Addendum 128 – Regulation No. 129

Amendment 2

Supplement 2 to the original version of the Regulation – Date of entry into force: 10 June 2014

Uniform provisions concerning the approval of Enhanced Child Restraint Systems used on board of motor vehicles (ECRS)

Arrangements of the approval mark

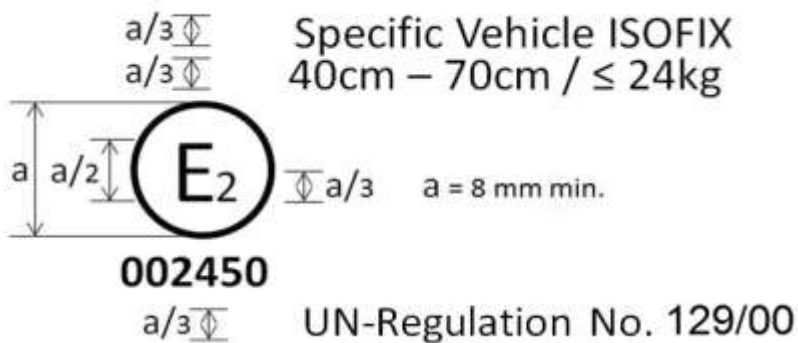
Annex 2, amend to read:

The Child Restraint System bearing the above approval mark is a device capable of being fitted in any i-size compatible vehicle seating position and of being used for the 40 cm to 70 cm size range and mass limit of 24 kg; it is approved in France (E 2) under the number 002439. The approval number indicates that the approval was granted in accordance with the requirements of the Regulation concerning the approval of Enhanced Child Restraint Systems used onboard of motor vehicles as amended by the 00 series of amendments. In addition the name of the regulation has to be identified on the approval mark followed by the series of amendment according to which the approval has been granted.

The Child Restraint System bearing the above approval mark is a device not capable of being fitted in every vehicle and of being used for the 40 cm to 70 cm size range and mass limit of 24 kg; it is approved in France (E 2) under the number 002450. The approval number indicates that the approval was granted in accordance with the requirements of the Regulation concerning the approval of specific vehicle ISOFIX child restraint systems used

"Figure 1

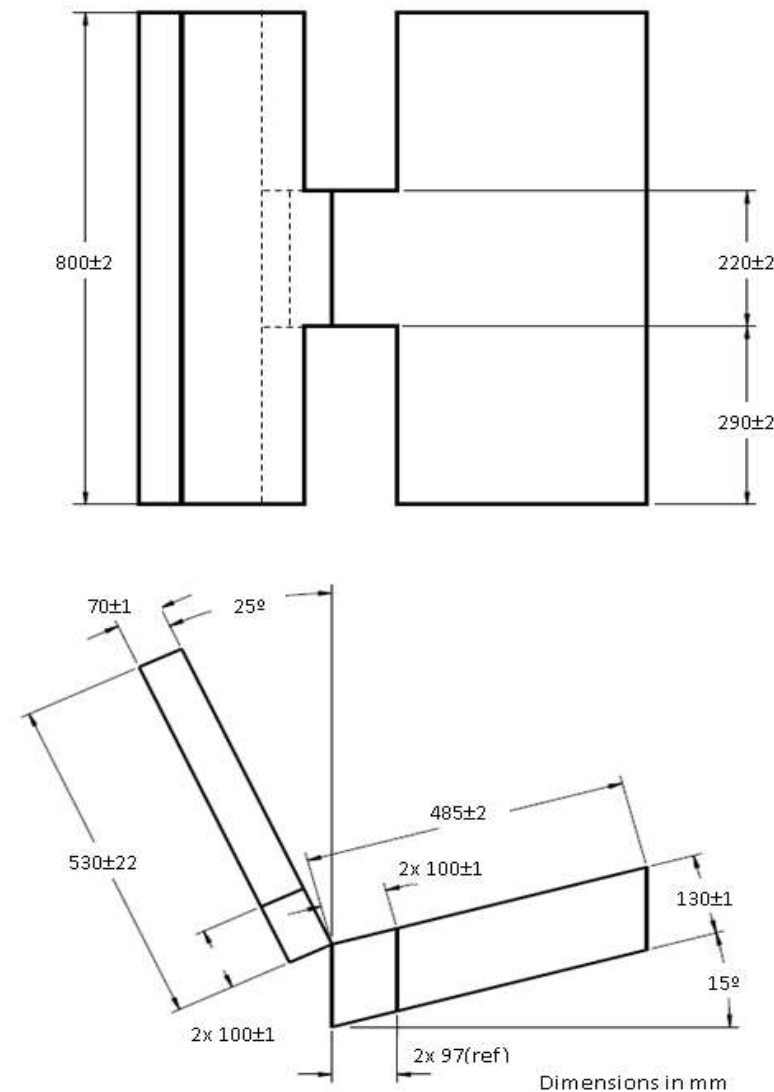
Figures 1 and 2, amend to read:

Dimensions of the seat and the seat cushions

"Figure 3
Dimensions of the cover material (dimensions in mm)

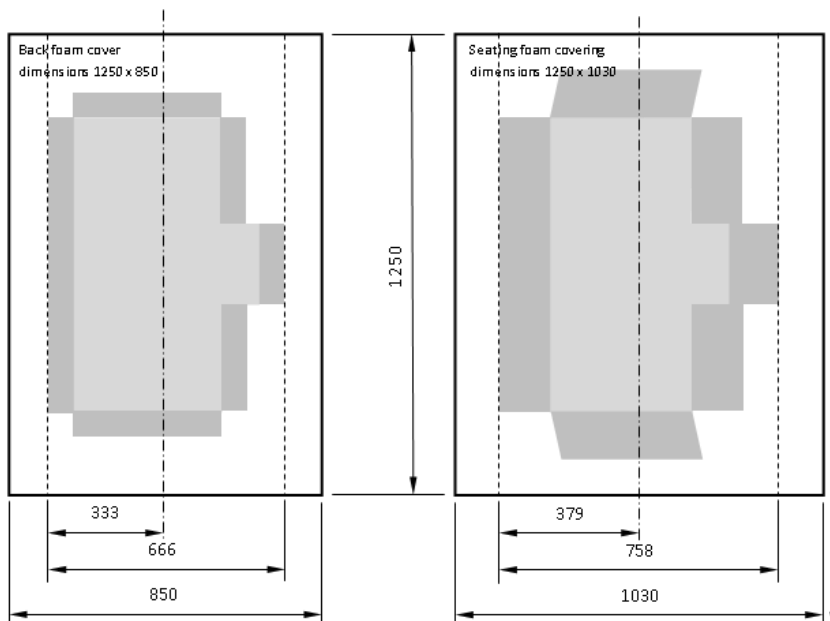
Figure 4 (former), renumber as Figure 3 and amend to read:

Figure 1
Side view of the support leg dimension assessment volume

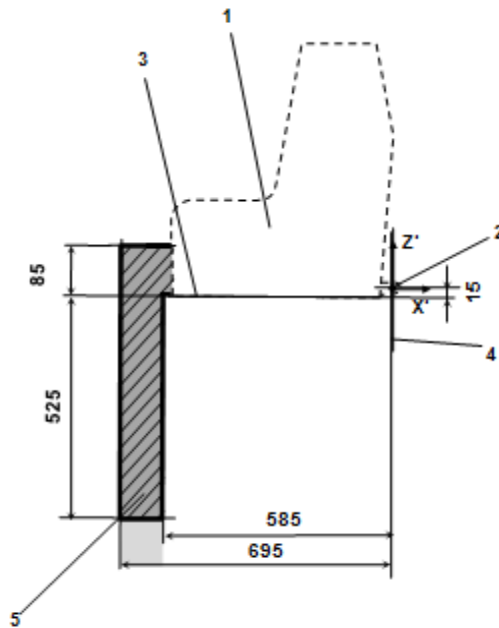
Annex 19, amend to read:

1. Child Restraint Fixture (CRF).
2. ISOFIX low anchorages bar.
3. Plane formed by the bottom surface of the CRF, which is parallel to and 15 mm below the X'-Y' plane of the coordinate system.
4. Z'-Y' plane of the coordinate system.
5. Upper part of the support-leg dimension assessment volume, which shows the dimensional limitations in X' and Y' direction, the upper height limit in Z' direction, as well as the lower height limitation in Z' direction for rigid, not in Z' direction adjustable support leg components.

Load application device I

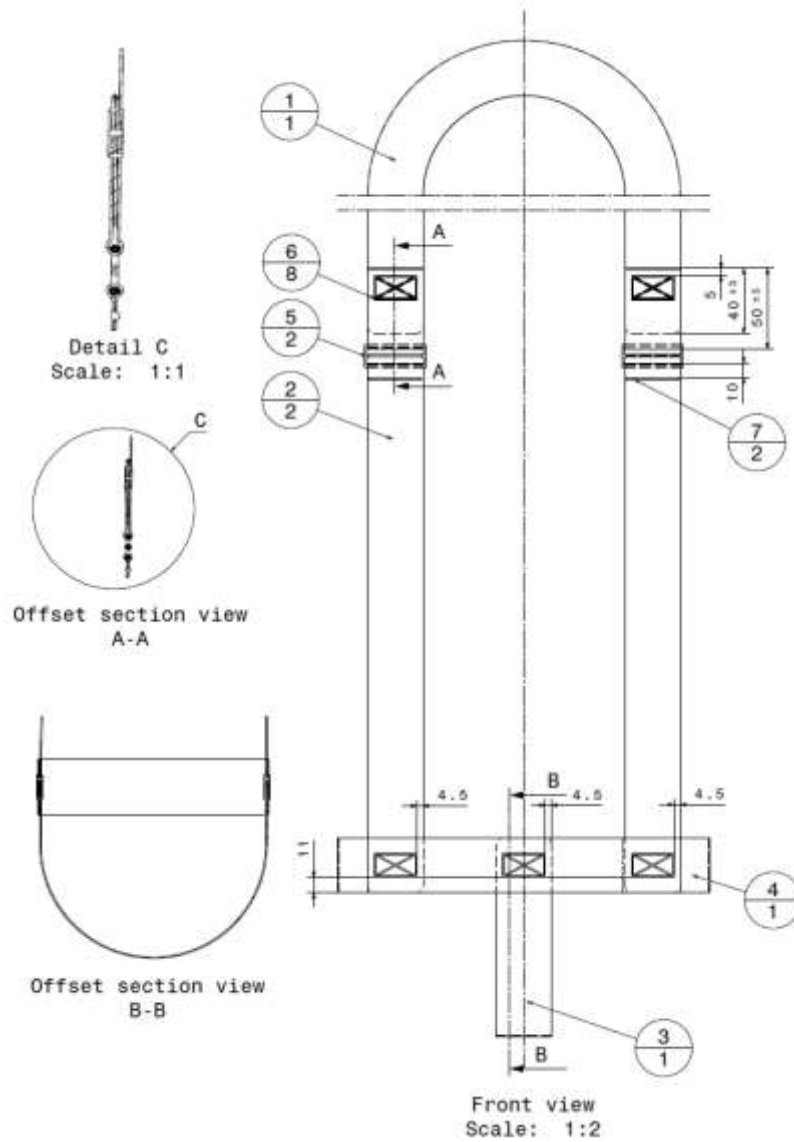
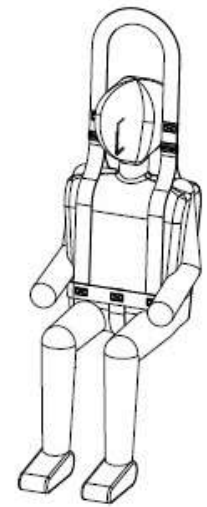
Insert new Annex 21, to read:
